# Re-Inspection & 3rd Walk Through Inspection of 1076 Fleming Way 7.19.06

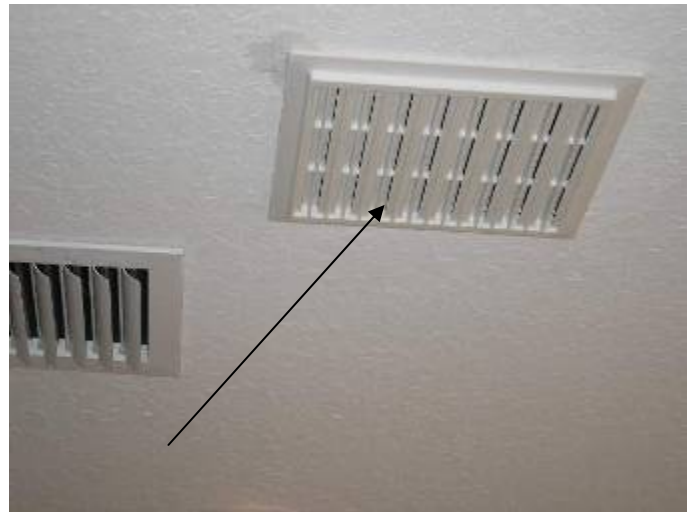
There was an unsealed gap between the door & frame at the garage/laundry area access. §13-606.1.ABC.1.2

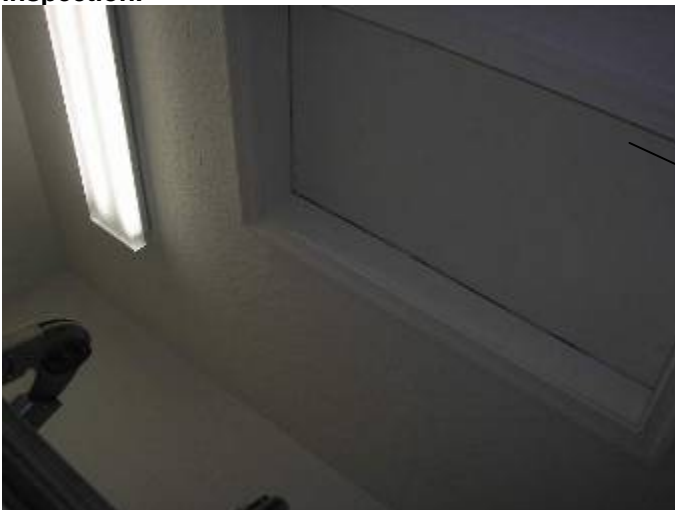
The exhaust vent fan was still very noisy & not operating correctly at the 2<sup>nd</sup> floor SW guest bathroom. The repair to the fan was in progress at the end of the inspection.

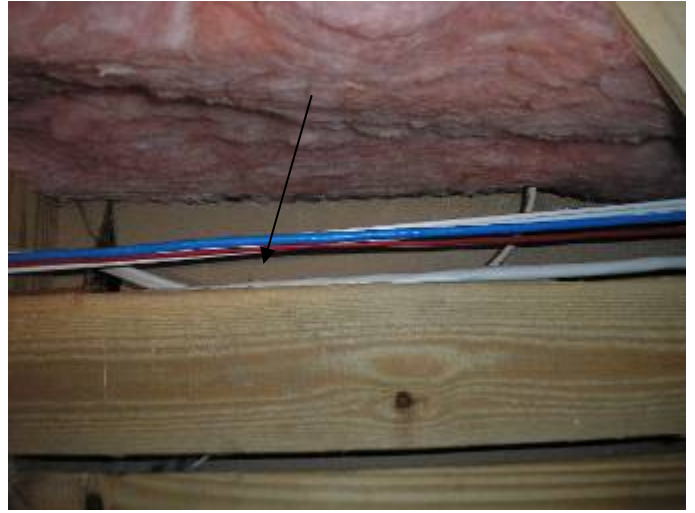
Some of the AC refrigerant line piping was not correctly supported in the attic. §M305.4

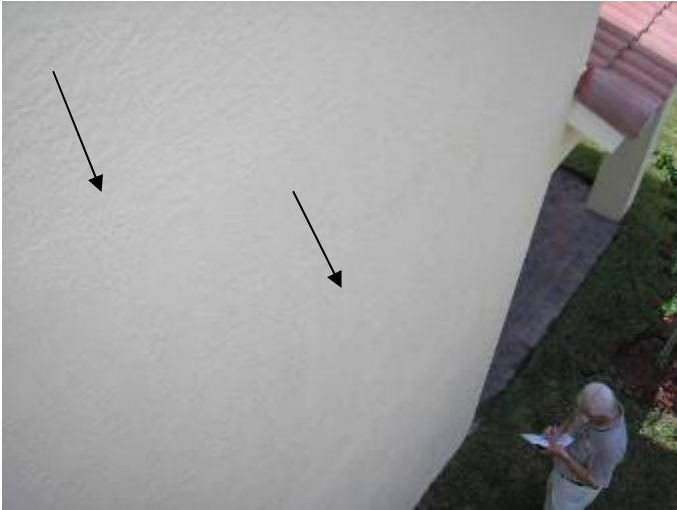
There were some broken tile pieces that were incorrectly "glued" back together with an RT-600 type adhesive product. These tiles should be removed & replaced.

**Thanks for your inquiry regarding our products. RT600 is specified for replacing an entire tile, not for gluing a broken tile back together. Please email or call (800) 624-7767 with any questions. Sincerely, BHeineking OSI Sealants / Tech Service**

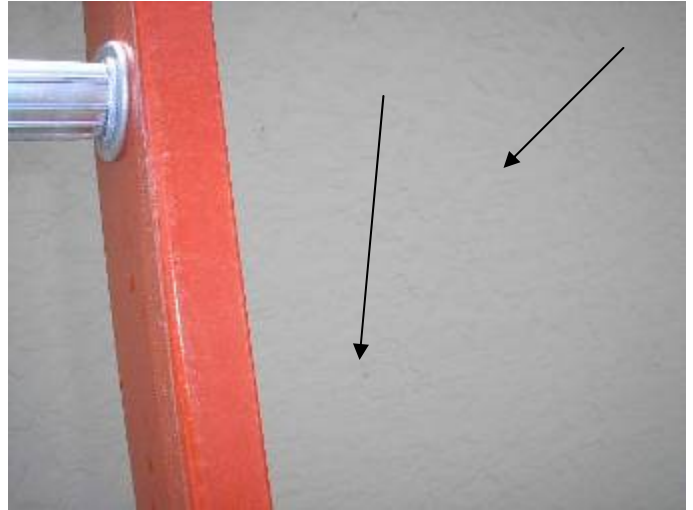
There were still some areas with exposed stucco & not enough paint on the exterior walls.

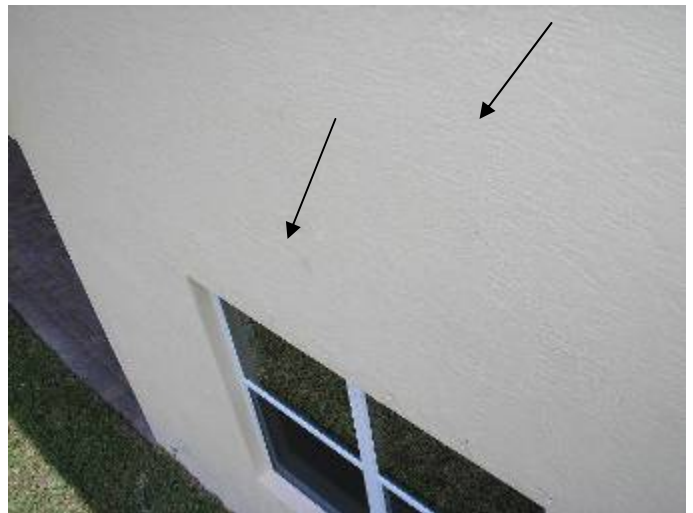
There were some broken tile pieces that were incorrectly "glued" back together with an RT-600 type adhesive product. These tiles should be removed & replaced.

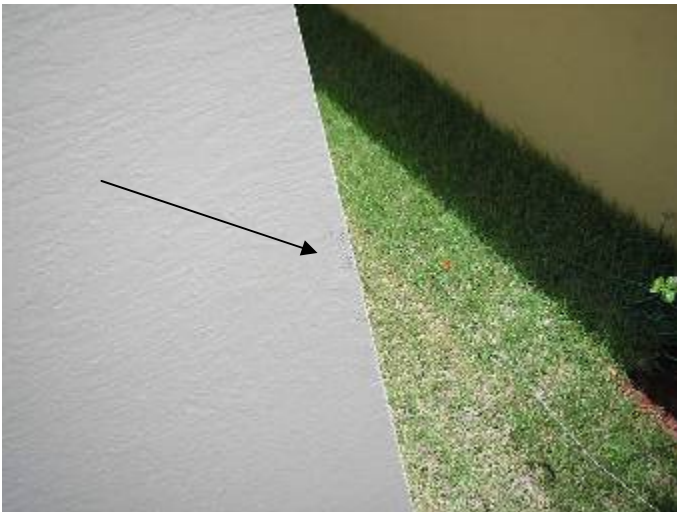
There were still some areas with exposed stucco & not enough paint on the exterior walls.

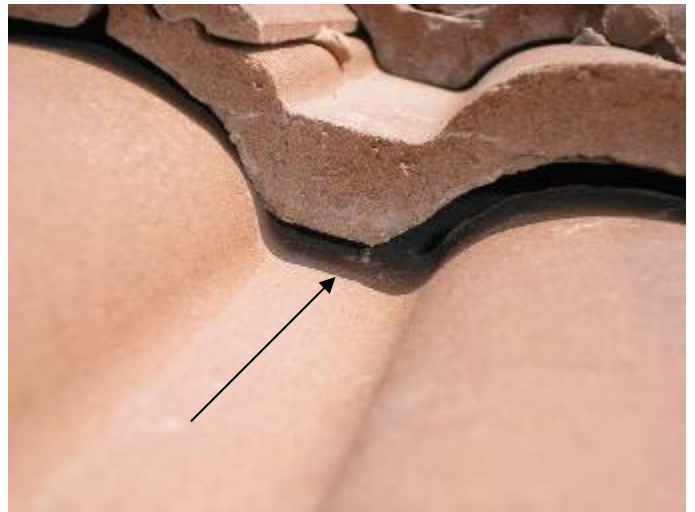
There is a roof tile anchor nail that is not fully set & holding up the adjacent tile. The nail should be properly set to allow the tile to be positioned correctly.

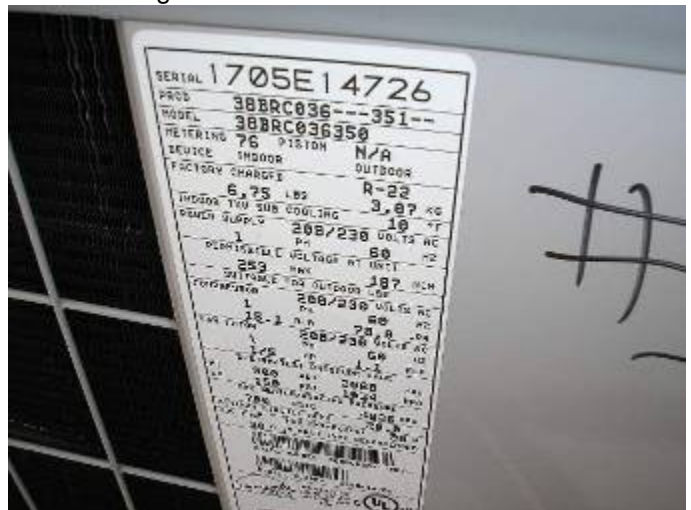
The A/C condensers are not secured properly. There are not enough straps or fasteners at the base of the units.

**The builder has documentation from the AC contractor's mechanical engineer approving the anchoring method used for these condensing units.**
